Applicant:	Kraus-Anderson Inc. (owner)
Location:	7803 Penn Avenue
Request:	1) Preliminary development plans for a partial redevelopment of the Southtown Shopping Center located at 7803 Penn Avenue S. to accommodate an approximately 120,000 square foot retail store and a future medical office building development phase; 2) Final development plans for an approximately 120,000 square foot retail store at 7803 Penn Avenue S. along with site modifications; 3) Preliminary plat to subdivide 7803 Penn Avenue S. into four lots to accommodate existing and proposed development; and 4) Platting variance to defer park dedication on future development phases until building permit issuance for that development phase.
Existing Land Use and Zoning:	Retail shopping; zoned C-3(PD) and C-5(PD)
Surrounding Land Use and Zoning:	North – Interstate 494 South – Mixed-Use and restaurants; zoned C-5 and C-5(PD) East – Hospitality and a vacant auto dealership; zoned C-4 West – Retail, restaurants, financial services; zoned CR(PD)

Case PL202400102

Project Description: Major Revision to Preliminary and Final Development Plans for a partial redevelopment of the Southtown Shopping Center; final development plan

Figure 1: Future Southtown Development Intensity

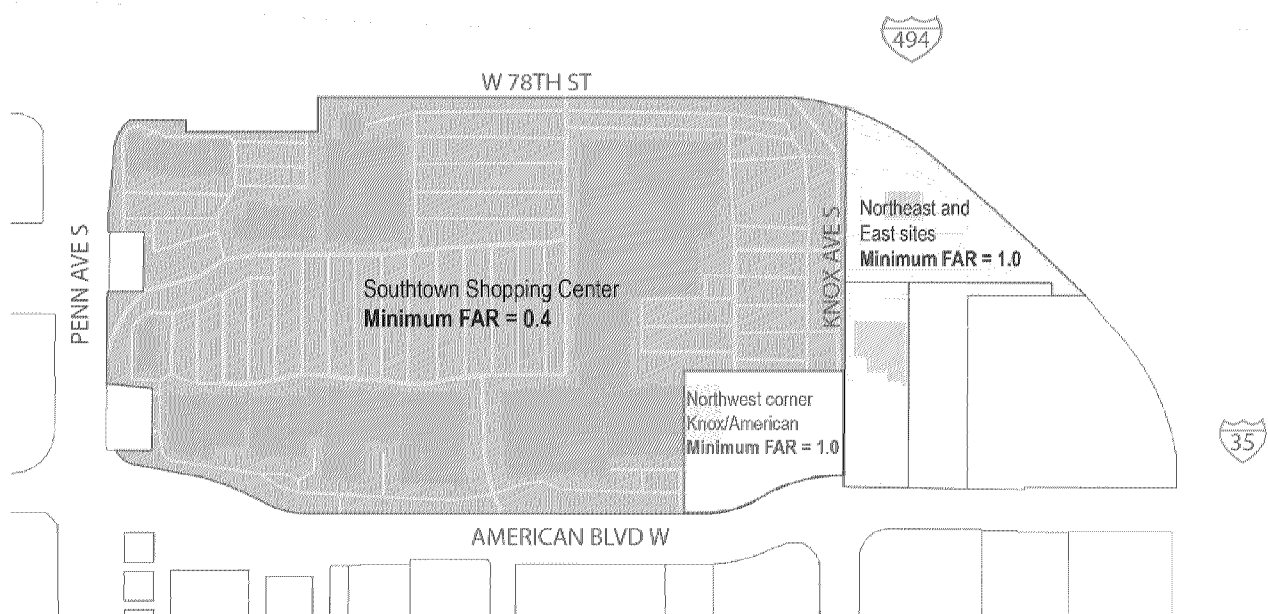
With a significant caveat, staff is supportive of the proposed PDP as it meets the desire of the applicant to bring in Dick’s House of Sport now, but sets the stage for additional future development. The proposed FAR for the main shopping center, identified as “Southtown Shopping Center” in Figure 1, will be approximately 0.37 after completion of the Dick’s and medical office phases. This FAR is 7.5 percent less than the 0.4 requirement established in the existing development agreement.

No future development phase is proposed in the Northwest corner Knox/American sub-area, which is zoned C-5. The minimum FAR in this area is 1.0. While no development is proposed now, intensive development that meets the minimum FAR is critical to implementing the vision established in the Penn American District Plan. Knox and American is a highly visible corner directly adjacent to a BRT station and warrants dense development. While not officially proposed as part of this application, the applicant included a conceptual development that could be implemented on the site. This conceptual phase consists of a six-story, 250-unit mixed use building with an FAR of 1.15. Sanitary sewer capacity is a concern in this area and the City is diligently studying

alternative funding scenarios to meet future sewer demand and allow future growth. While staff is supportive of the proposed preliminary development plan, staff does not support eliminating the minimum 1.0 FAR requirement in the Northwest corner Knox/American sub-area as memorialized in existing development agreements with the applicant.

A third sub-area, “Northeast and East sites,” is not included in the proposed preliminary development plan. This area is also critical in implementing the Penn American District Plan but is being treated as an independent site from Southtown Shopping Center. The applicant had submitted a massing graphic depicting two additional development phases in the Northeast and East sites, although those phases are purely conceptual. Nonetheless, it depicts the dense, pedestrian-friendly, and transit supporting development envisioned in the Penn American District Plan.

1. Ongoing Planned development flexibility regarding floor area ratio is not granted to the portion of the planned development zoned C-5. Future development on the C-5 portion of the planned development must meet a 1.0 minimum floor area ratio standard unless otherwise compliant with the Bloomington City Code or flexibility is granted through the Planned Development process.
